**Natural Resources Defense Council
The Bay Institute
American Rivers
Audubon California
California Sportfishing Protection Alliance
Friends of the River**

October 27, 2014

**RE: Comments on the Upper San Joaquin River Basin Storage Investigation Draft
Environmental Impact Statement**

Figure 1 Reduction in spills under Alternative 4

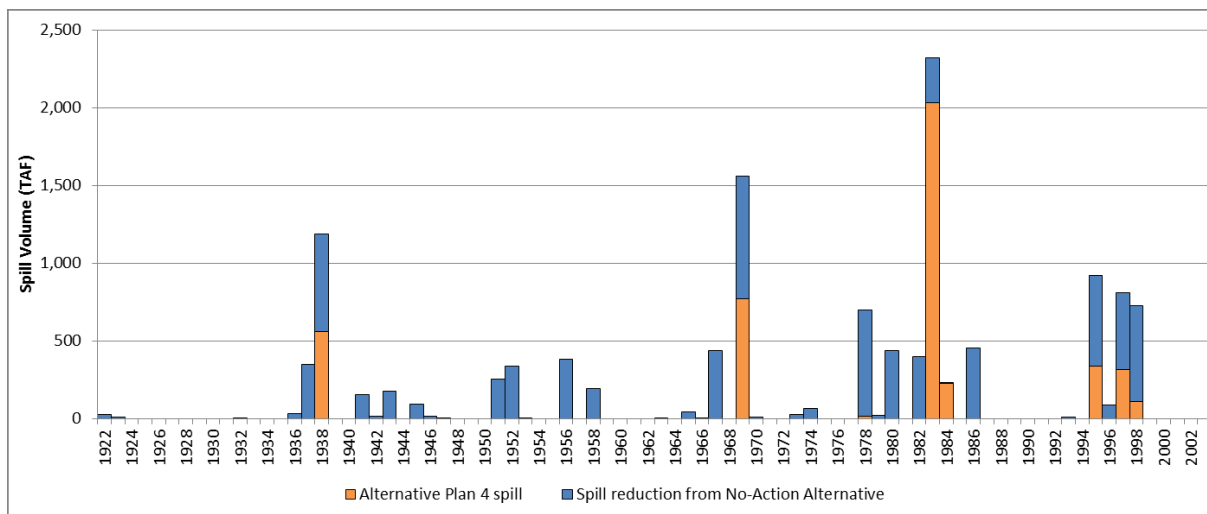
Other Social and Ecological Impacts: Moreover, the focus on a single species fails to account for the potential impact of Temperance Flat reservoir on species upstream and downstream of the proposed reservoir. The Investigation clearly identifies these losses in habitat and impacts on other wildlife and fisheries, but does nothing to quantify these costs in the cost-benefit analysis:

None of these ecosystem/social costs are evaluated in the plan, leaving a gaping hole in the understanding of the potential project impacts and in the benefits-costs analysis. Reclamation should incorporate modeling efforts to determine actual losses of habitat and subsequent economic losses, including the cost of compensatory mitigation measures.
